TECHNICAL REVIEW OF DOE DOCUMENTATION ON CLOSURE OF ANCILLARY EQUIPMENT AT THE F-TANK FARM FACILITY, SAVANNAH RIVER SITE

Date: September 2023

NRC Technical Review

This technical review report focuses on DOE documentation related to closure of ancillary equipment at the F-Tank Farm Facility, Savannah River Site, Aiken, South Carolina. Summaries of the primary documents listed above are provided in Appendix A. Technical reviews of the documents listed above are the basis for NRC’s evaluation of DOE’s closure of ancillary equipment at the F-Tank Farm Facility, discussed next.

Figure 4. Plan View Maps of FDB-5 and FDB-6 Cell Covers. Image Credit: Figures 2.1-1 and 2.5-3 of SRR-CWDA-2020-00011.

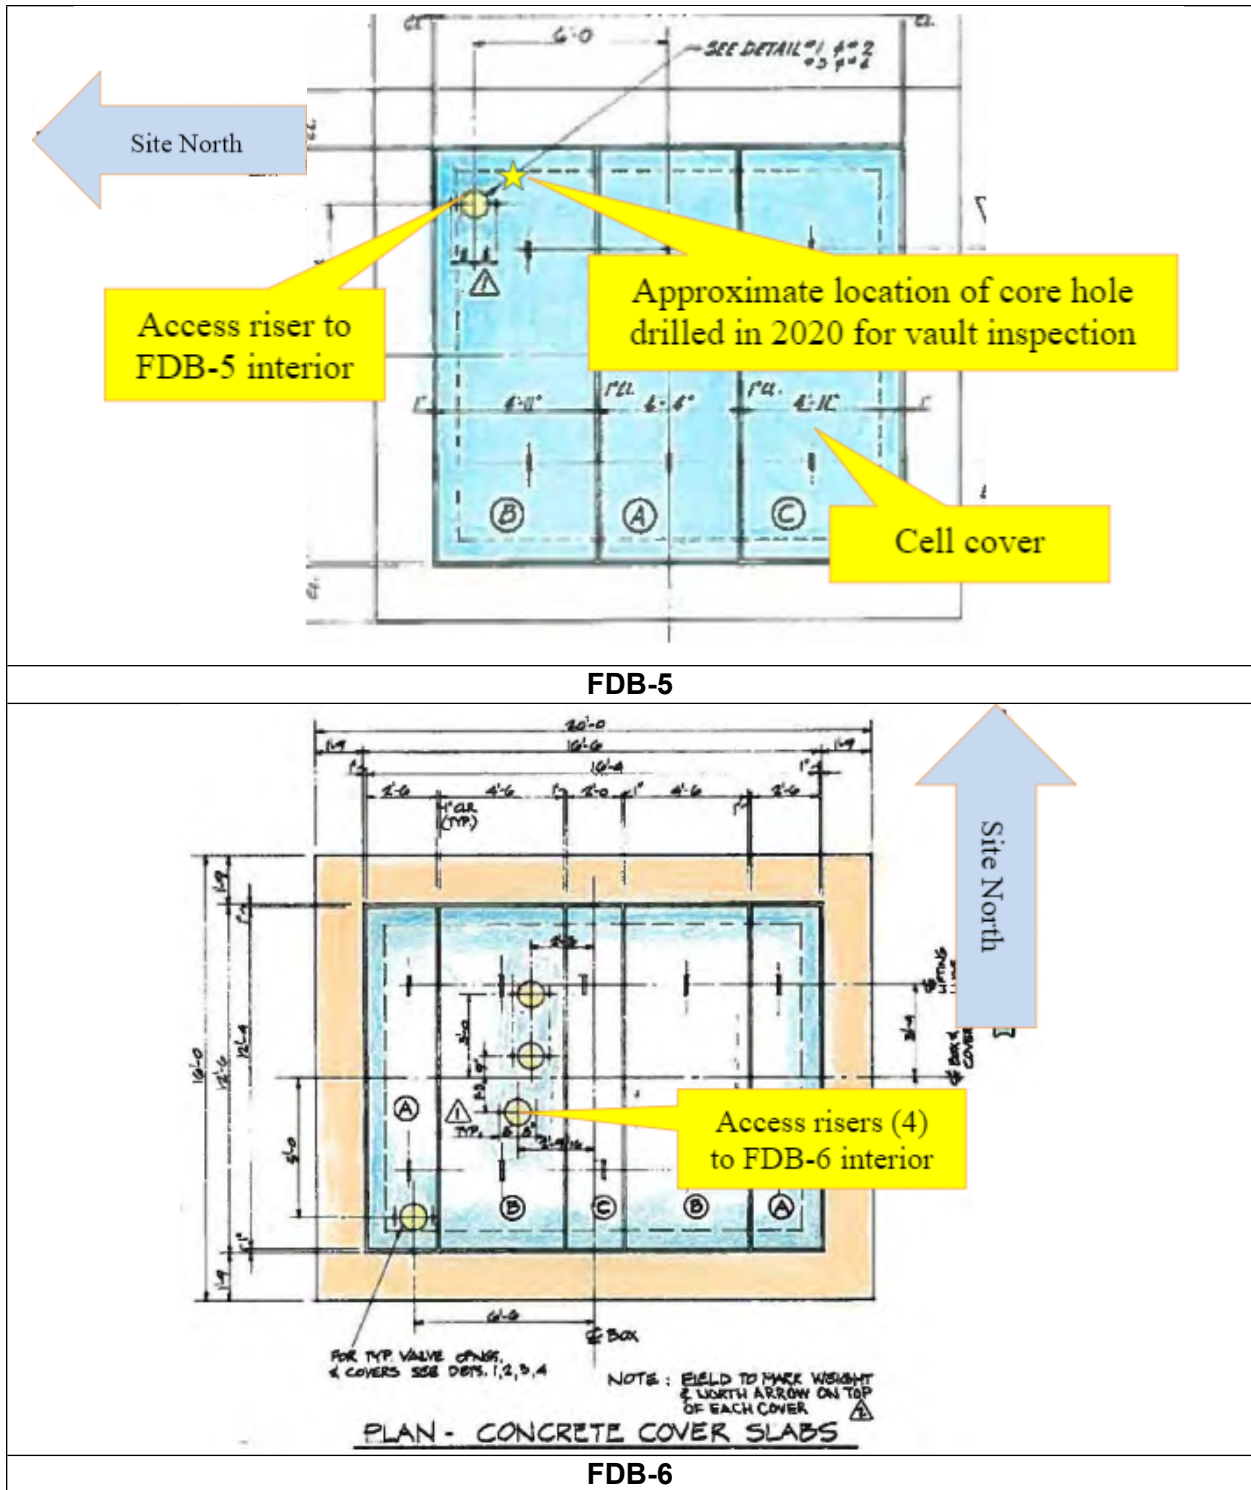
NRC also recommends that DOE clarify in future documentation the reason for and expected radiological status of abandoned jumpers in the diversion boxes (e.g., clarify whether the jumpers were plugged prior to abandonment, and if so, the degree of flushing and waste dissolution that occurred prior to abandonment of the jumpers in the diversion boxes). NRC staff also recommends that DOE look for opportunities to better validate the method used to estimate volumes of residual radioactivity remaining in the abandoned jumpers that had historically been plugged in future assessments, as conditions warrant.

Figure 9. Map of FTF PA Model Showing Locations of FDB-5 and FDB-6 Sources.

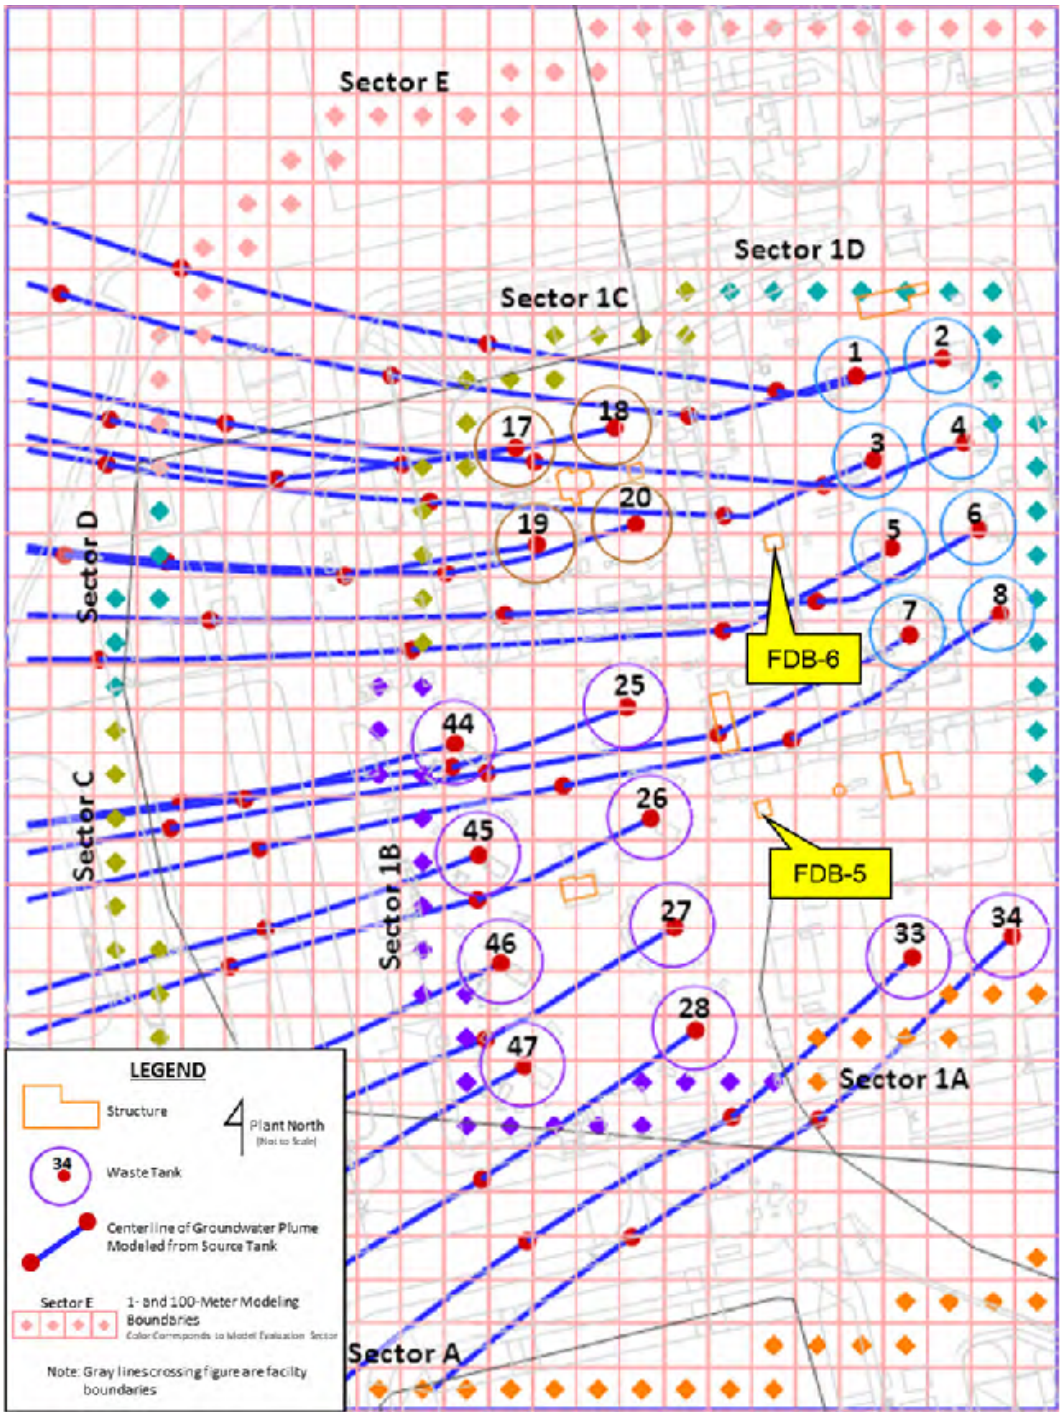
DOE prepared this SA considering the Tanks 18/19 and Tanks 5/6 SAs. DOE simply added two new sources to represent FDB-5 and FDB-6 (Figure 9). The contributions to peak dose from the diversion boxes were negligible. The updated SA estimate for the maximum dose to a future hypothetical member of the public within 10,000 years and resulting from waste potentially remaining in FDB-5 is 6×10^{-5} mSv/yr (0.006 mrem/yr) in Sector C and from waste potentially remaining in FDB-6 is 1×10^{-4} mSv/yr (0.01 mrem/yr) in Sector D and is primarily associated with Technetium (Tc)-99 and Neptunium (Np)-237 (SRR-CWDA-2020-00055). The 1-m doses to an inadvertent intruder were also insignificant with the largest dose less than $< 3 \times 10^{-4}$ mSv/yr (0.03 mrem/yr) compared to the 0.7 mSv/yr (70 mrem/yr) dose from all sources.

- The results of the SA using the estimated inventories for FDB-5 and FDB-6 reveal negligible contributions to overall peak dose at FTF. The updated SA estimated the maximum potential dose to a future hypothetical MOP resulting from the waste in FDB-5 at 6×10^{-05} mSv/yr (0.006 mrem/yr) and from FDB-6 at 1×10^{-04} mSv/yr (0.01 mrem/yr).
